# CITY OF ALBUQUERQUE

RE: **Heritage Marketplace Tract A2 (Burger King)**  
**7900 Ladera Dr NW**  
**Grading and Drainage Plan**  
**Engineer's Stamp Date 03/08/18 (File: H09D024A)**

RE: Heritage Market Place, Tract A2 (Burger King) (H09D024A)

RE: **Heritage Marketplace Tract A2 (Burger King)**  
**7900 Ladera Dr NW**  
**Grading and Drainage Plan**  
**Engineer's Stamp Date 12/27/17 (File: H09D024A)**

ENGINEER'S SEAL RICHARD H. DOURTE NEW MEXICO REGISTERED PROFESSIONAL 10854 3/08/18 Richard Dourte P.E. #10854	Title: BURGER KING 7900 LADERA DRIVE NW GRADING AND DRAINAGE PLAN	DRAWN BY DATE
	RHD Engineering, LLC 4305 Purple Sage Ave. NW ALBUQUERQUE, NM 87120 (505) 288-1621	SHEET # 1 of 2 JOB #

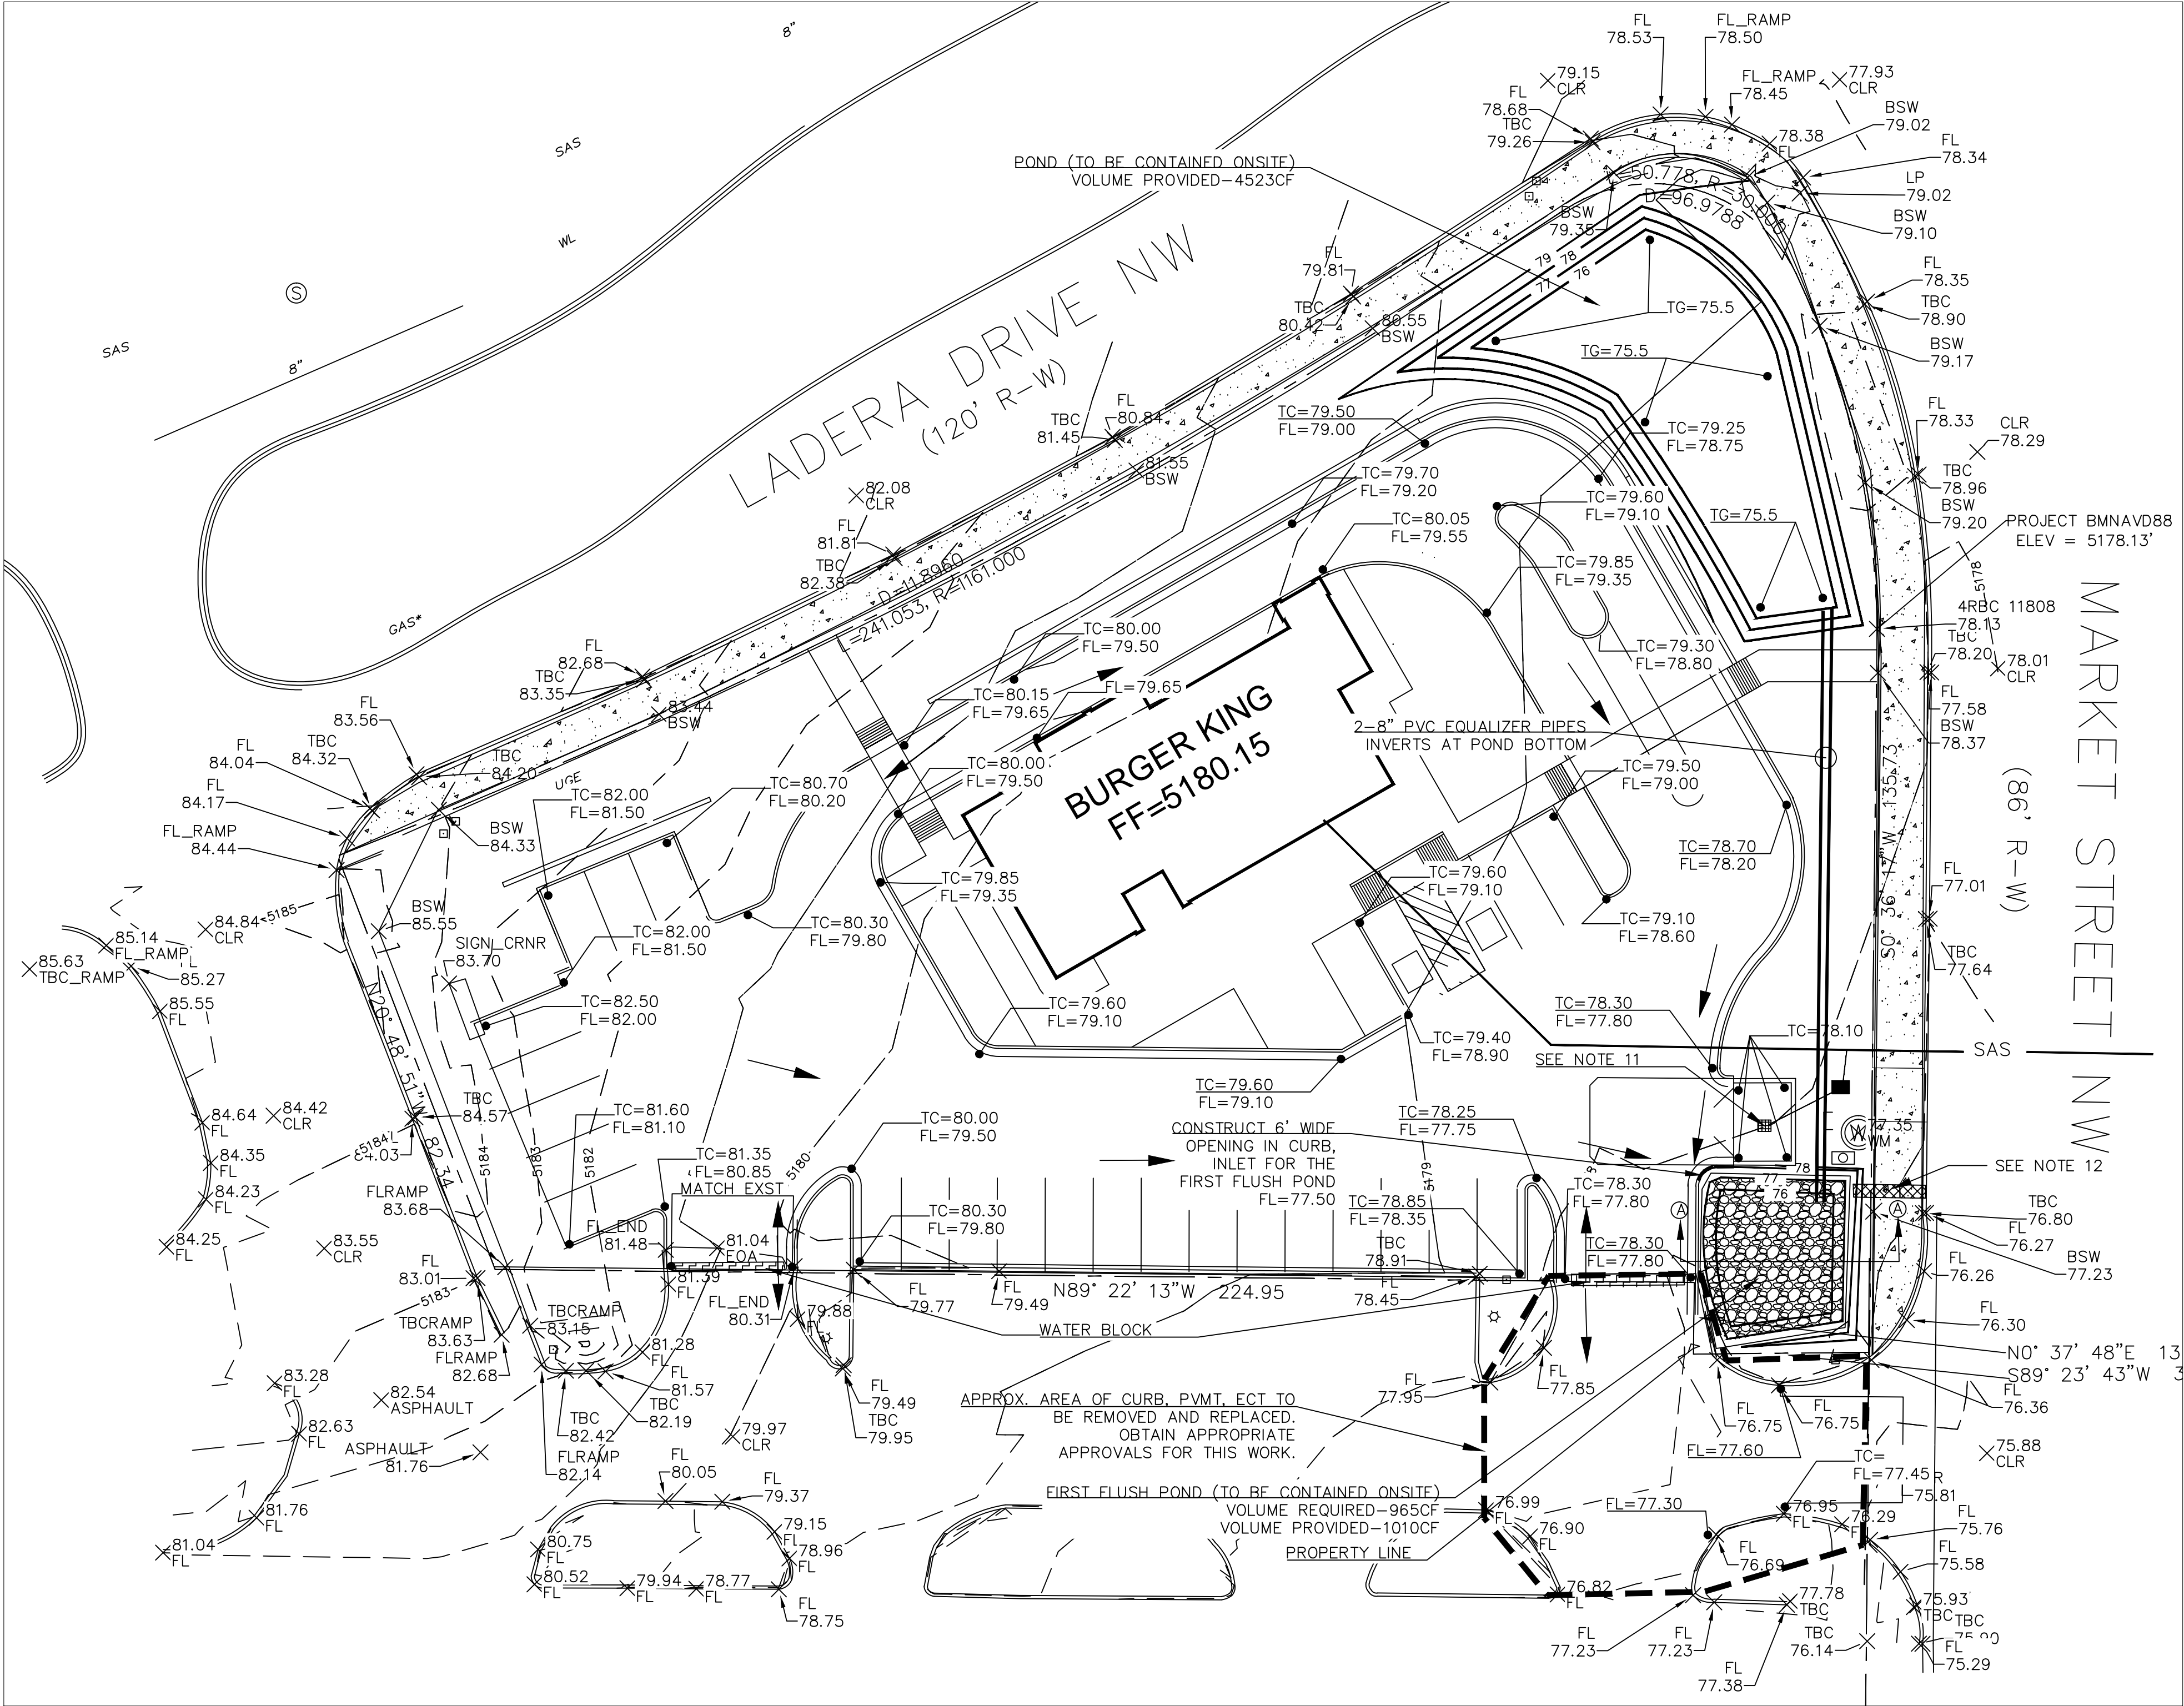
Based on the information provided in your submittal received 3/8/18, the Grading and Drainage Plan is approved for Site Plan Building Permit, Grading Permit, Building Permit and SO-19 Permit.

Please ensure this Grading Plan and the updated Landscaping Plan are included in the Site Plan For Building Permit, prior to final signatures.

1. The Drainage Covenant must be recorded with Bernalillo County and a copy included with the drainage certification.
2. Payment of Fee-in-Lieu will be required for any ponding areas not constructed and certified.

Based on the information provided in your submittal received 12/27/17, the Grading and Drainage Plan is approved for Site Plan Building Permit with the condition that written permission from the adjoining property owner (Walmart) for work on their property be received prior to DRB approval of the Site Plan.

1. A detailed grading and drainage plan, with the "conceptual" markings removed will be required for Building Permit.
2. A Private Facility Drainage Covenant is required for the stormwater quality pond. The original notarized form, exhibit A (legible on 8.5x11 paper), and recording fee (\$25, payable to City of Albuquerque) must be turned into DRC (4th, Plaza del Sol) for routing. Please contact Charlotte LaBadie (clabadie@cabq.gov, 924-3996) or Madeline Carruthers (mtafoya@cabq.gov, 924-3997) regarding the routing and recording process for covenants.
3. Additional comments may be provided at Building Permit, based on the outcome of the above remarks and level of detail shown on plans.

Please find attached the drainage and grading plan for building permit for the site referenced above. Also note that there was a pond added at the northeast corner of this site. It was determined by the client that it would be desirable to contain the 100yr-6hr storm water volume onsite. Other than the addition of the new pond, the two equalizer pipes, and the emergency overflow now goes to Market Street, the drainage concept is the same as the approved "Conceptual Grading and Drainage Plan" stamp dated 12-27-17.

1. The "conceptual" marking has been removed.
2. The Private Facility Drainage Covenant will be provided as a requirement for Building Permit with the exhibit "A" on a 8.5" x 11" paper that shows the as-built condition.
